# Intel<sup>®</sup> Pentium<sup>®</sup> III Processor Specification Update

Release Date: July 2001

Order Number: 244453-032

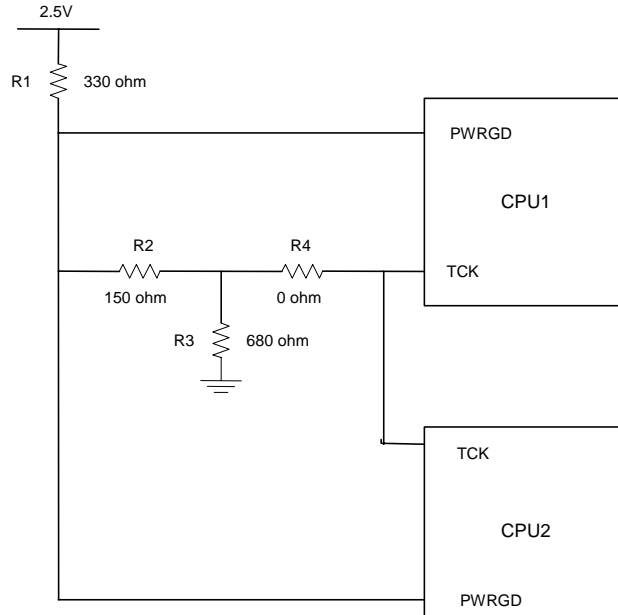
**Problem:** The internal control register bit responsible for operation of the Thermtrip circuit functionality may power up in a non-initialized state. As a result, THERMTRIP# may be incorrectly asserted during de-assertion of RESET# at nominal operating temperatures. When THERMTRIP# is asserted as a result of this erratum, the processor may shut down internally and stop execution but in few cases continue to execute.

**Implication:** This issue can lead to intermittent system power-on boot failures. The occurrence and repeatability of failures is system dependent, however all systems and processors are susceptible to failure. In addition, the processor may fail to stop execution during the event of a valid THERMTRIP# assertion resulting in the potential for permanent processor damage.

**Workaround:** To prevent the risk of power-on boot failures or catastrophic thermal failures, a platform workaround is required. The system must provide a rising edge on the TCK signal during the power-on sequence that meets all of the following requirements:

- Rising edge occurs after Vcc\_core is valid and stable
- Rising edge occurs before or at the de-assertion of RESET#
- Rising edge occurs after all Vref input signals are at valid voltage levels
- TCK input meets the Vih min and max spec as mentioned in EMTS
